Access Compliance Report

Public Rights-of-Way (Curb Ramps)

Intersection ID: N/A	Main Street: AGNEW_DR	Cross Street: COWGILL_LN	Location: SW
ADA ID: 4145482E3EF4	Ramp Type: Perp	Initial Pass/Fail: Pass	Overall Compliance: No
		Severity Score: 0

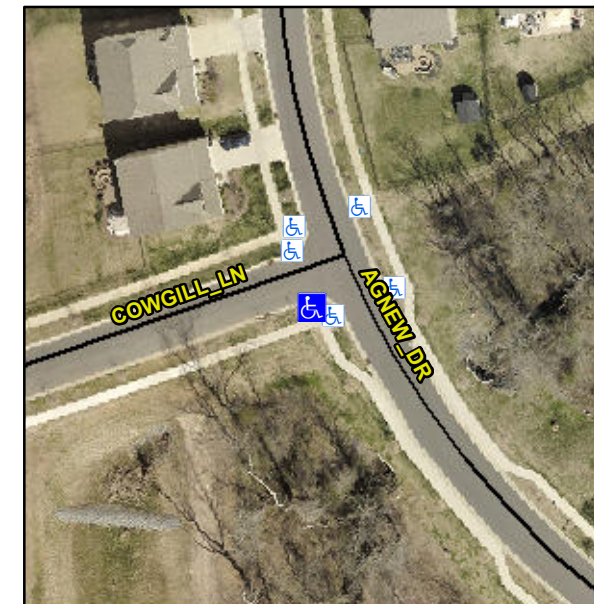
PROW/ADA:

R305.2

**Remove & Replace Detectable
Warning System.**
